MEMPHIS AND SHELBY COUNTY OFFICE OF PLANNING AND DEVELOPMENT

**STAFF REPORT
CORRESPONDENCE ITEM**

CASE NUMBER: P.D. 06-314 CC L.U.C.B. MEETING: July 10, 2008

DEVELOPMENT NAME: Lee Line Farms Planned Development

Proposed Grading and Drainage Plan

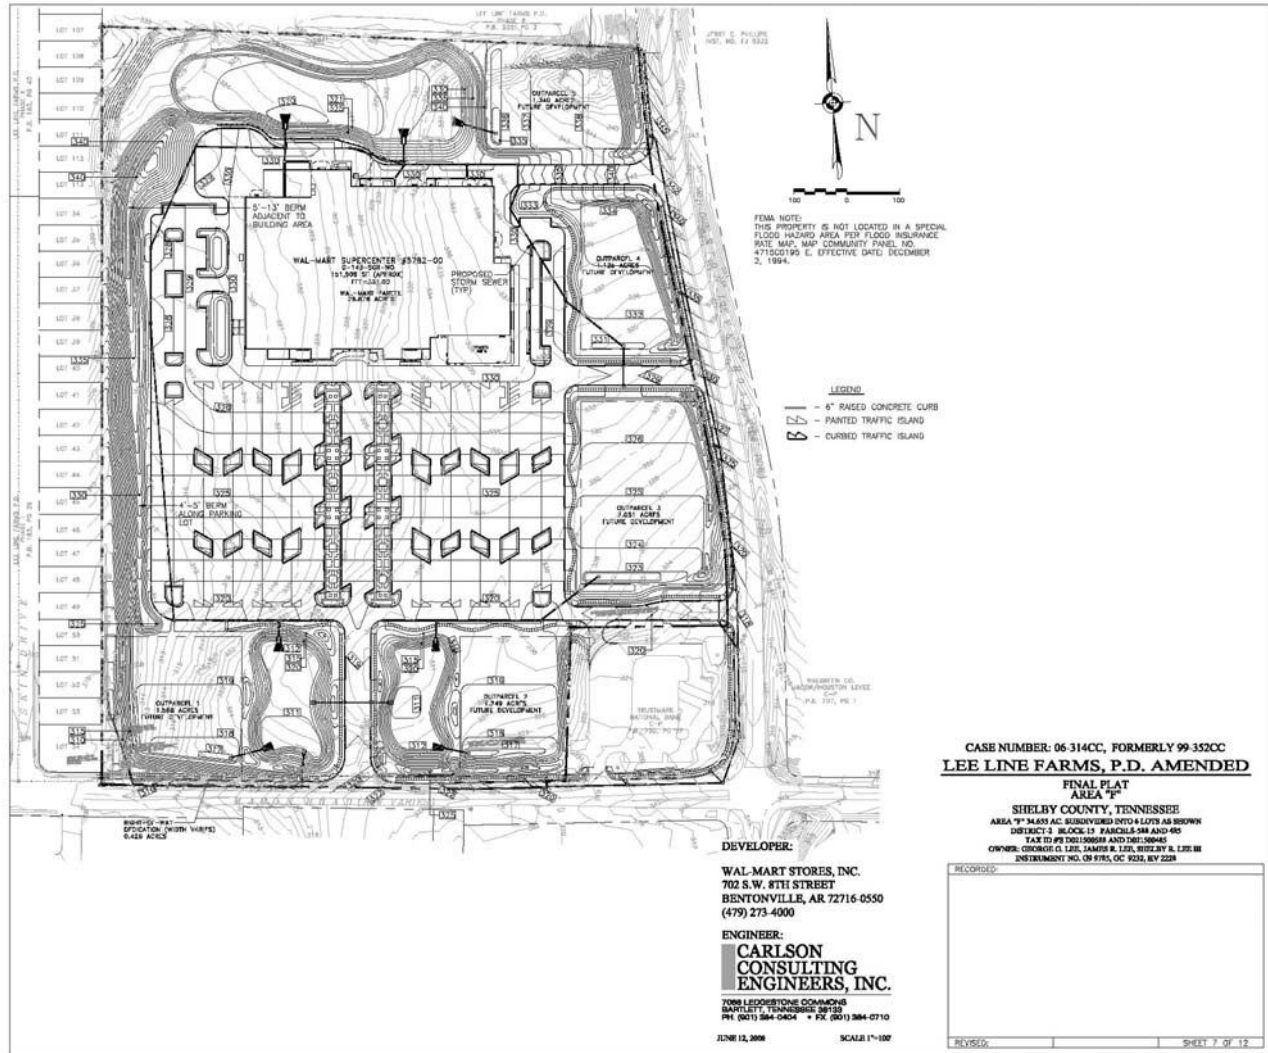
On Page 14 of the staff report, the proposed grading and drainage plan is illustrated. Such information is invaluable in determining compatibility and impact of proposed developments. One could easily question that the applicant should have the right to develop the supercenter simply on the merits that almost 100,000 square feet less of floor area is being provided and the building location is much more removed from the adjoining residences. The concept plan itself is a long-range guide of what can be developed on the site, but depending on how this development is arranged and the landscape physically altered may lead to the concept plan not being workable. It is important to remember that the proposed improvements by Wal-Mart still place the supercenter building at nearly the highest finished grade point on the property, so what might appear to be a much better plan than the approved concept plan could be deceiving depending on the final improvements to the site. For instance, the approved conceptual plan building location might be adequate, if, perhaps the site is graded down to eliminate the substantial ground elevation above the homes along Siskin Drive. This comparison needs to be noted simply because an approved concept plan should not give anyone the right to expect to be able to adhere to it without mitigating adverse impacts first which could result in development that simply cannot match the concept plan.

FIGURE 8
RECOMMENDED IMPROVEMENTS

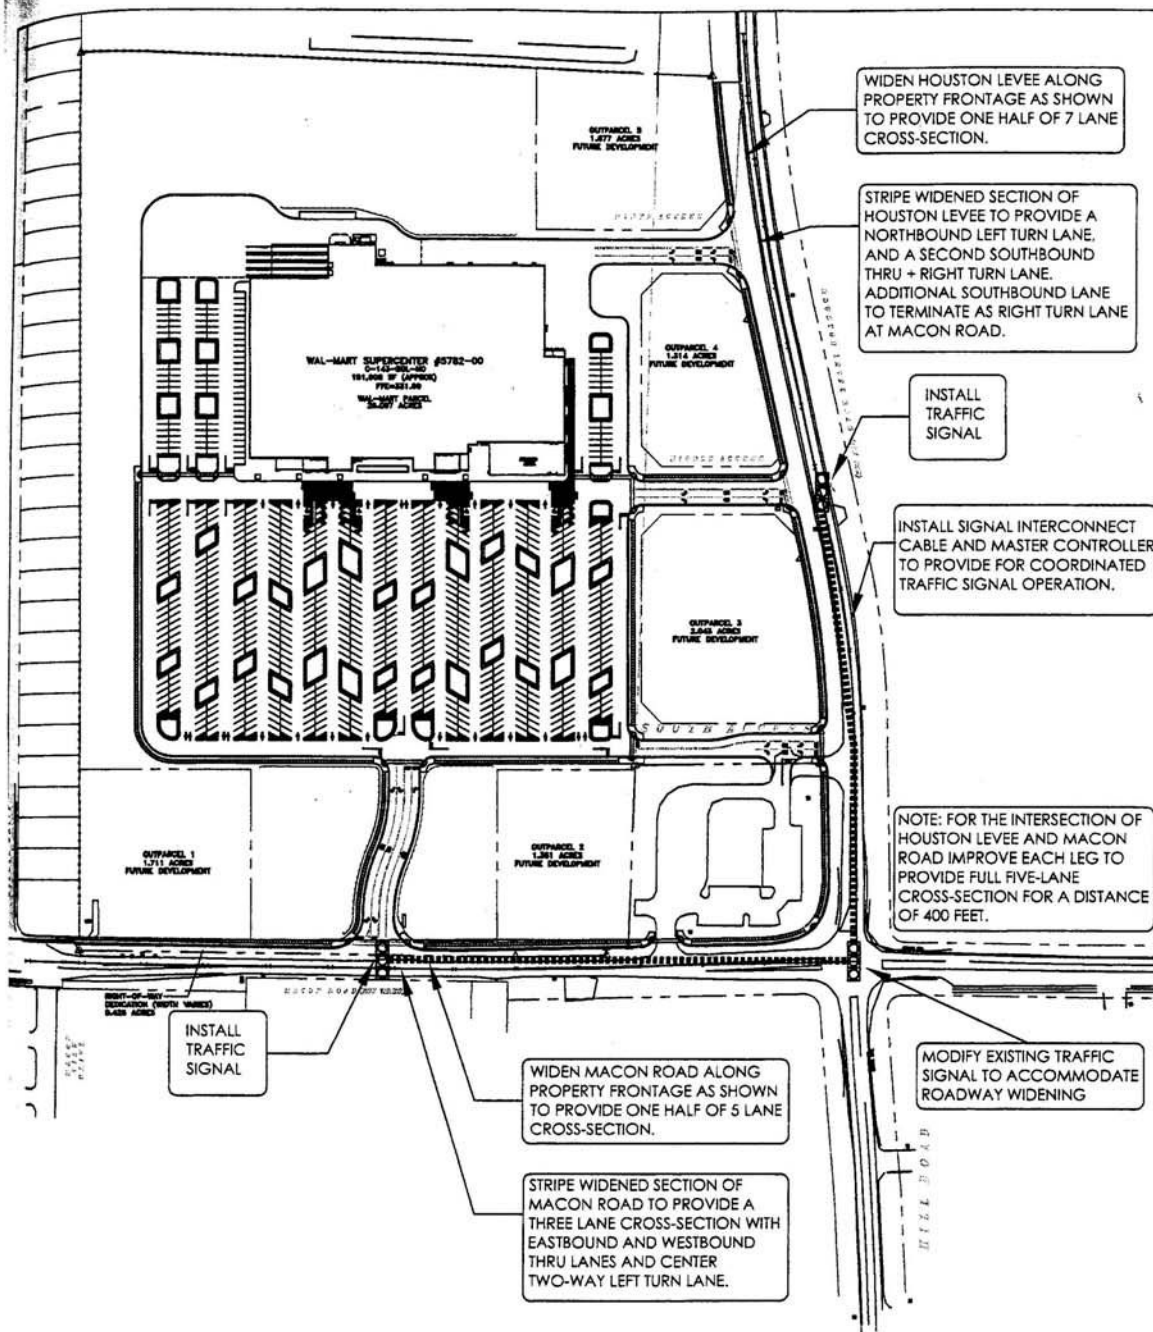
The traffic counts for the study were taken during the time school was not in session for Macon-Hall Elementary which is immediately west of the subject property on Macon Road and is well known to area residents for its back up of traffic in the mornings and afternoons when school is in session. This seems to be a deficiency in the study.

The OPD Staff has recently met with the County Engineer to discuss the traffic study. The conclusion of the County Engineer is that while the offer by Wal-Mart to extend full roadway improvements in all four directions at the intersection for up to 400 feet in each direction is good, the proposed supercenter development will nonetheless create demands on county infrastructure that cannot be met in the foreseeable future. It was suggested by the County Engineer that if the project were approved, conditions be added to assure full 5-lane road improvements in all directions at the intersection up to 800 feet.

The analyses presented in this study indicate that the traffic generated by the site can be accommodated with certain traffic control and roadway improvements. These improvements are shown in Figure 8 and are described as follows:

- **Widen Houston Levee Road** - Widen Houston Levee Road along project frontage to provide one half of a seven lane cross-section. The widened section of Houston Levee Road should be stripped to include a northbound left turn lane and a second southbound thru + right turn lane. The additional southbound lane should terminate as a right turn only lane at Macon Road.

- **Install Traffic Signals** - Recommend installation of a traffic signal at the intersection of Houston Levee Road and the middle project access. A traffic signal is also recommended for the intersection of Macon Road and the Wal-Mart driveway access.

- **Install Signal Interconnect Cable** - To provide for coordinated signal operation, fiber-optic communications cable should be installed between the proposed Wal-Mart traffic signals and the existing traffic signal at Macon Road and Houston Levee Road. In addition, a master controller should be provided.

- **Modify Existing Traffic Signal** - The existing traffic signal at the intersection of Macon Road and Houston Levee Road will need to be modified to accommodate the roadway widening.

- **Widen Macon Road** - Widen Macon Road along project frontage to provide one half of a five lane cross-section. The widened section of Macon Road should be marked as three lanes to include eastbound and westbound thru lanes and a center two-way left turn lane.

- **Additional Intersection Widening** - To address County staff concerns, widen the intersection of Houston Levee and Macon Road to a five lane cross-section for 400 feet in all four directions.
